V2500-A1 SERIES PROPULSION SYSTEMS SERVICE BULLETIN

This document transmits Revision 1 to Service Bulletin EV2500-73-0038 and the Initial Issue of the Supplement

V2500-ENG-73-0038

ENGINE - FUEL AND CONTROL - PROVIDE A NEW P2/T2 PROBE AIR TUBE ASSEMBLY AND
ATTACHMENT AT CLIPPING POINT CP0603

Location of P2/T2 tube assembly and clipping point CP0603
Fig.1

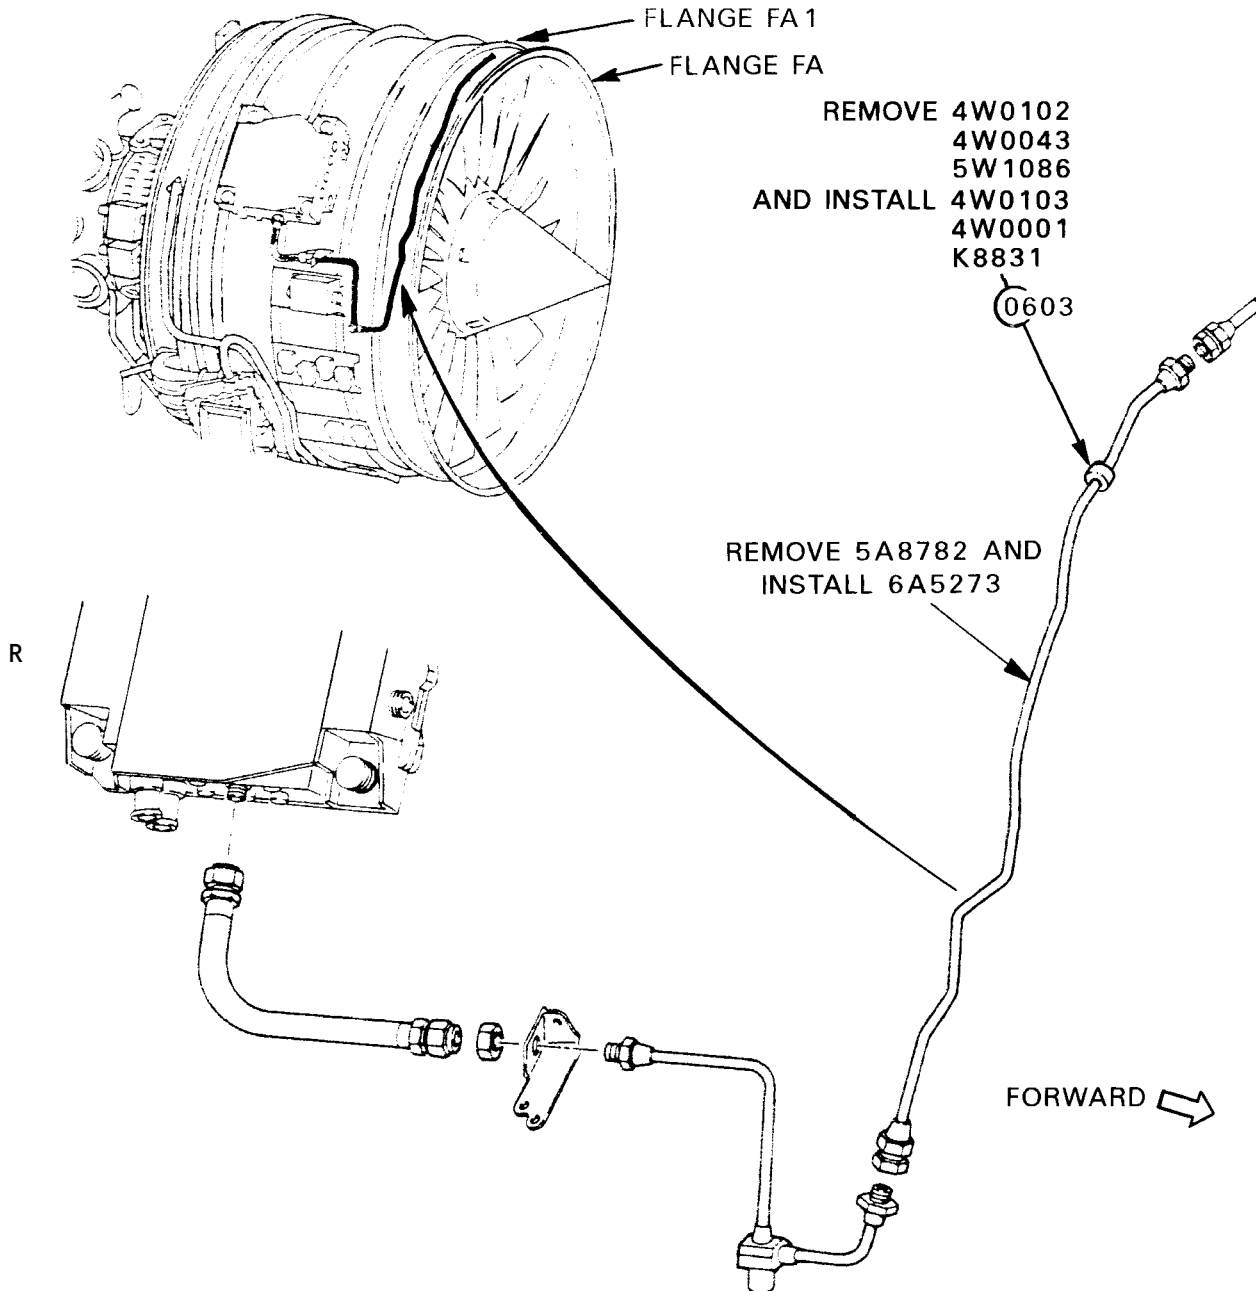
- (1) A new P2/T2 tube assembly, re-routed locally at clipping point 0603.
- (2) The arrangement of clipping point 0603 has been changed by moving the clip to the inboard side of the bracket and replacing the clip nut with a nut and washer.

- (1) Disassemble clipping points 1053, 1054, 1055 and 0603 sufficiently to remove the 5A8782 tube. Refer to Figure 1.
- (2) Disconnect the couplings at each end of the 5A8782 tube and remove the tube.
- (3) Install the 6A5273 tube and connect the hose and tube couplings.
- (4) Assemble clipping points 1053, 1054 and 1055.
- (5) Assemble the modified clipping point 0603 using the new 4W0103 bolt, K8831 washer and 4W0001 nut. Refer to Figure 2.
- (6) Torque the hose nut to 135 to 145 lbfin (15,26 to 16,39 Nm).
- (7) Torque the tube coupling nut to 70 to 80 lbfin (7,9 to 9,0 Nm).
- (8) Safety the hose nut and the tube coupling nut with CoMat 02-126 lockwire.
- (9) Torque the bolts at clipping points 1053, 1054, 1055 and 0603 to 36 to 45 lbfin (4 to 5 Nm).

Clipping point CP0603 - Before and after alteration
Fig.2

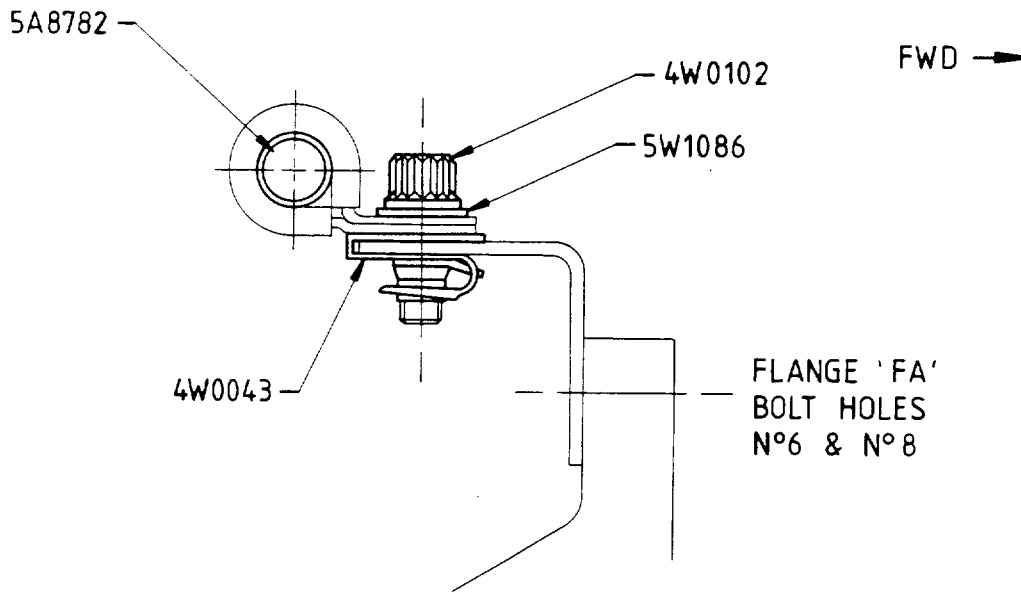
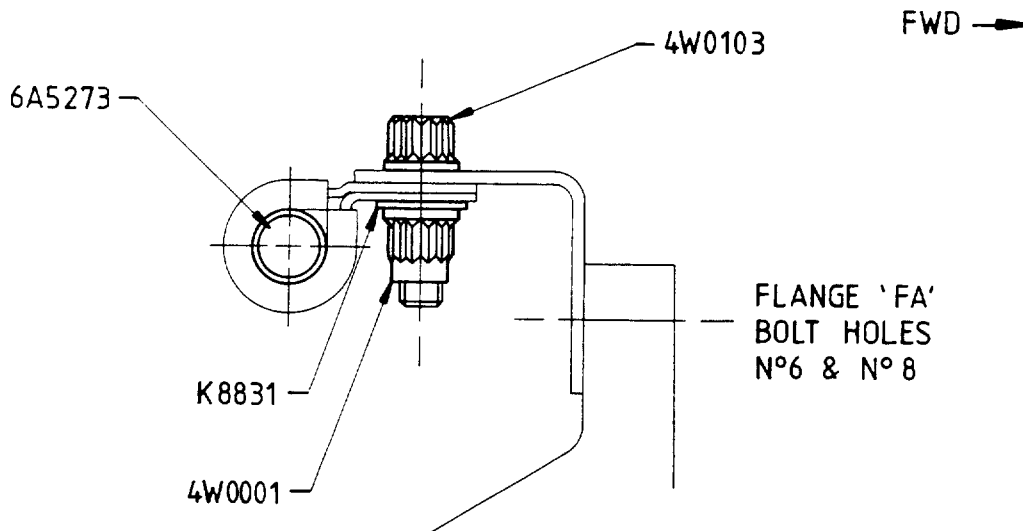
R The arrangement of clipping point 0603 has been changed by moving the clip to
R the inboard side of the bracket and replacing the clip nut with a nut and
R washer.

CLIPPING POINT 0603 BEFORE ALTERATION

CLIPPING POINT 0603 AFTER ALTERATION
